RE: Inland Wetlands Commission Application
Project Site: 131 Danbury Road
Contract Purchaser: 131 Danbury Wilton Dev AMS LLC
(an affiliate of AMS Acquisitions, LLC)

SLR Project No.: 21543.00001

**RE: Wilton Inland Wetlands and Watercourses Agency Review
Application for a Significant Regulated Activity
Application #2904(S) ASML Acquisitions, LLC
131 Danbury Road, Wilton, Connecticut**

PROJECT NO. 21543.00001, SHEET NO. 09 OF 23, TOWN OF WILTON, CONNECTICUT
DATE: 10/23/2023, SCALE: 1"=20', DRAWN BY: RYAN SUTHERLAND, CHECKED BY: AMS ACQUISITIONS

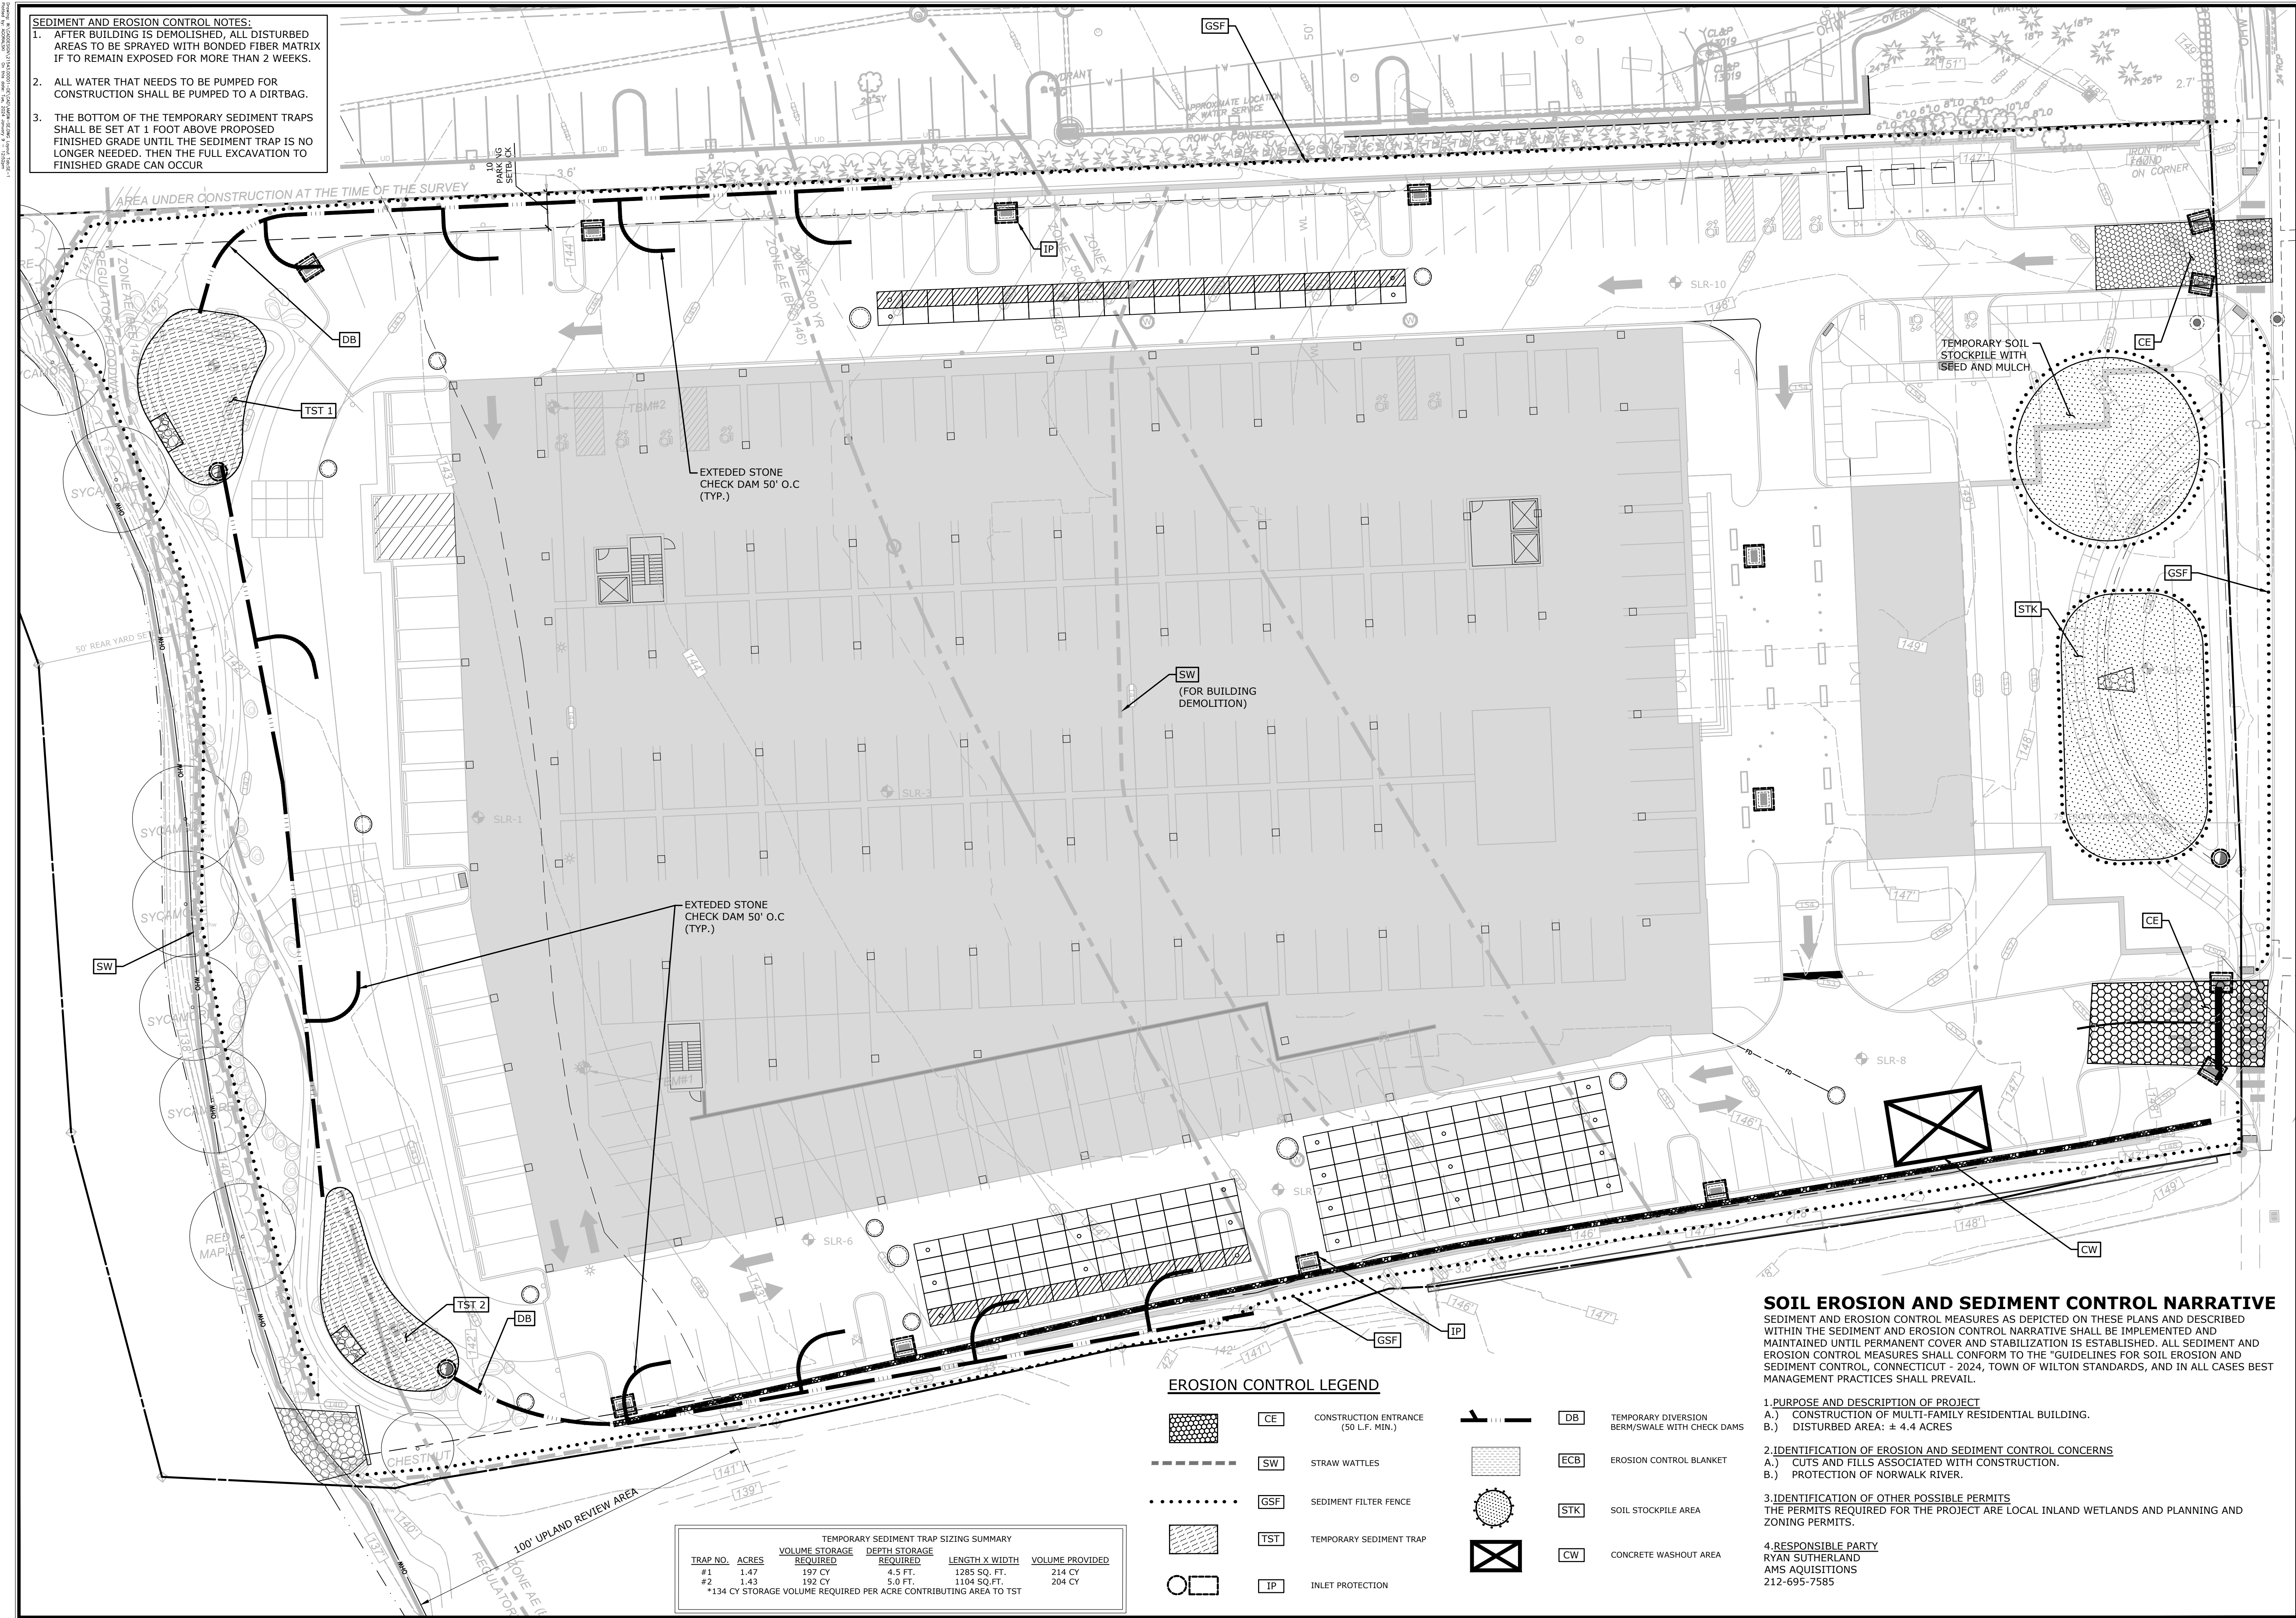
- R. WWI-7: **An arrow has been added to Sheet SE-1 to show the overflow direction of the sediment traps.**

- R. SE-1-5: A concrete washout location has been added to Sheet SE-1 and detail to Sheet SE-2.**
- C. SE-1-6: Soil stockpile areas are in the area of the "Wildflower Meadow" in the front of the property. Where are stockpiles to be relocated during work in this area? This area may be hard to access during start of construction due to proximity of existing building. A phased soil erosion plan to address issues where stockpiles may need to be moved as site is built out seems helpful.

CONCRETE UTILITY PAD
NOT TO SCALE

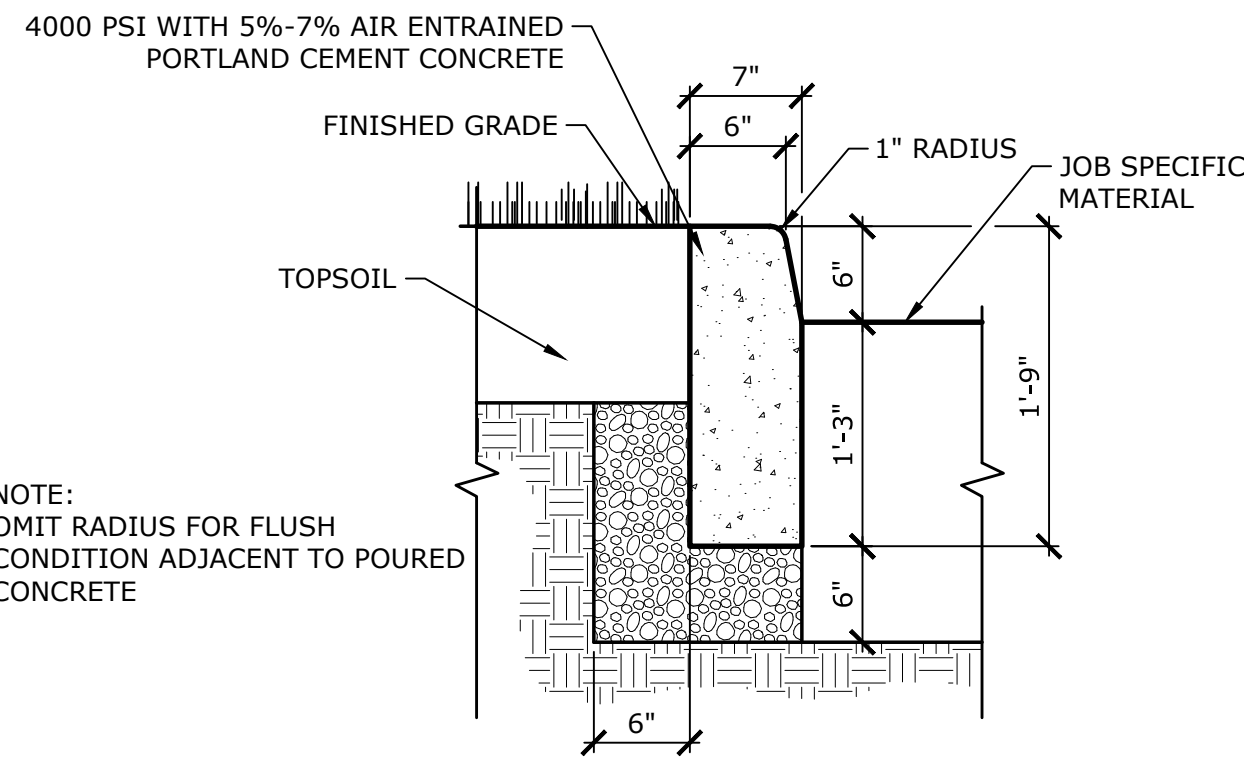
R. SD-2-4: Utility pad detail has been added to Sheet SD-1.

STORMWATER INFILTRATION RAIN GARDEN

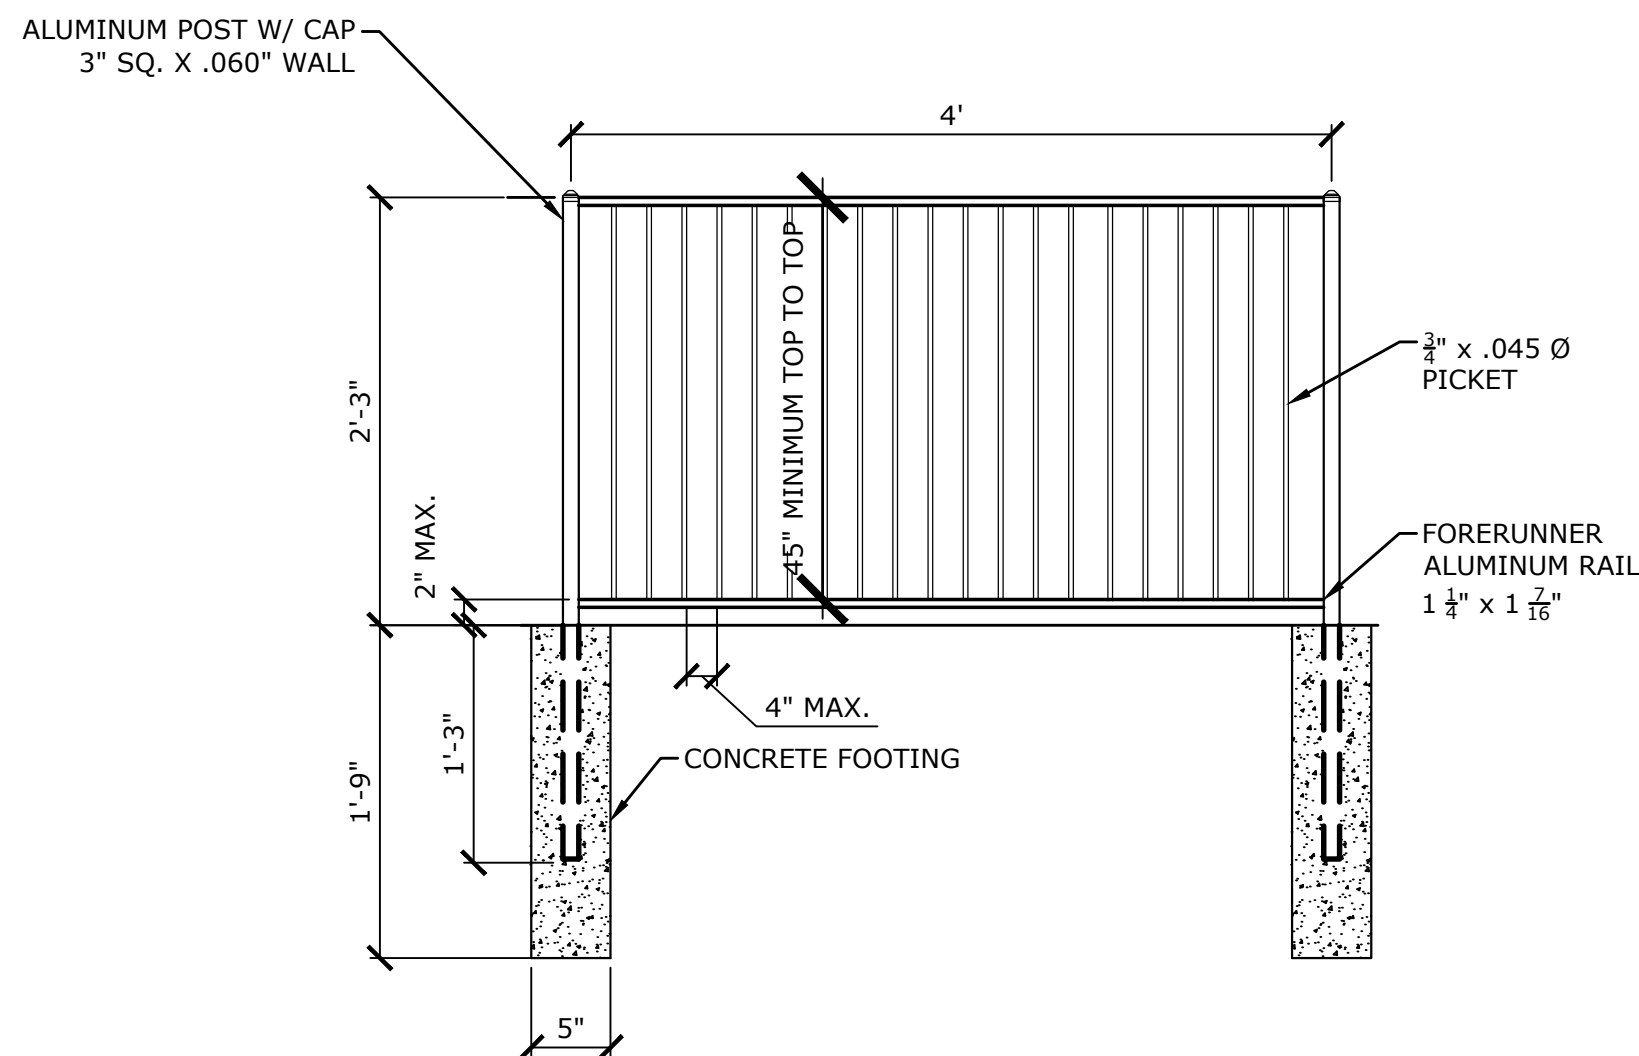
- R. SD-4-10: A Town of Wilton Standard Manhole detail has been added to Sheet SD-4.**
- C. SD-4-11: Rain Garden and Filter Strip Detail – “Rain Gardens” are not identified as such on plans. Coordinate plans and details with same nomenclature. Show location of the infiltration strip on plans. Revise detail to correspond with site plans.

VH-1

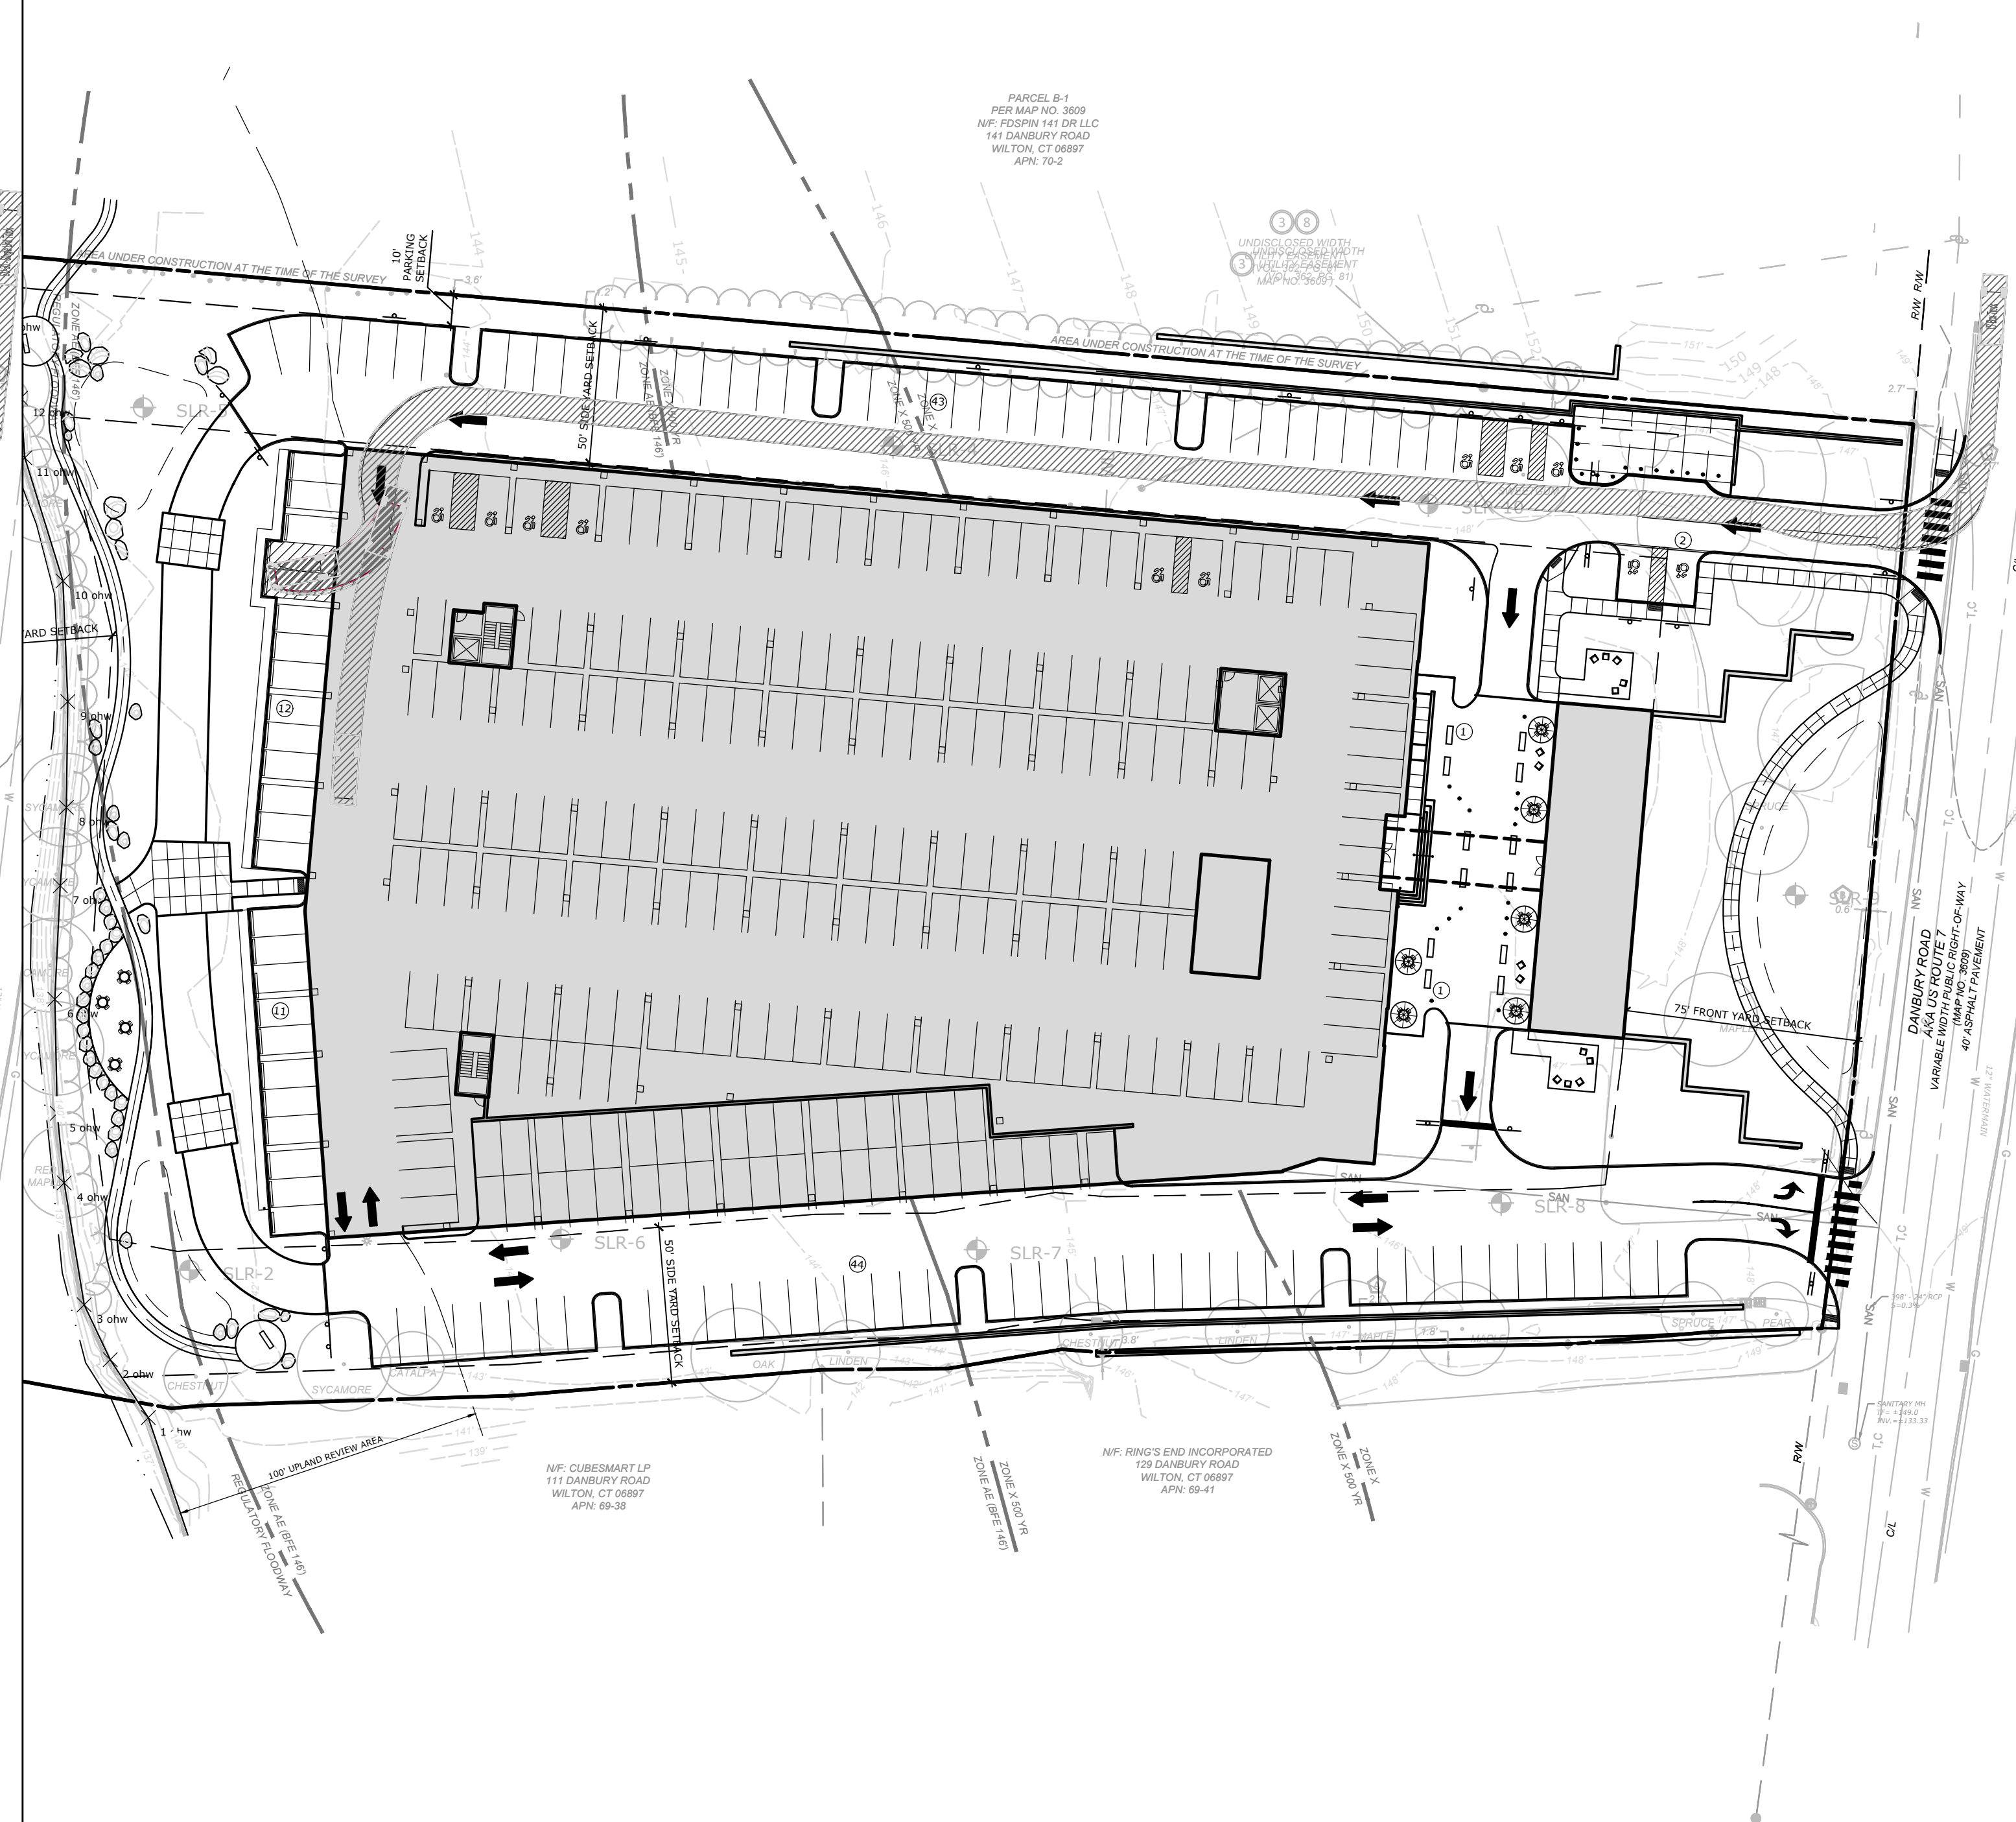
- R. LA-12: See Sheet VH-1 for fire truck turning movements. Additionally a fire consultant has been retained to coordinate with the Wilton Fire Department.**
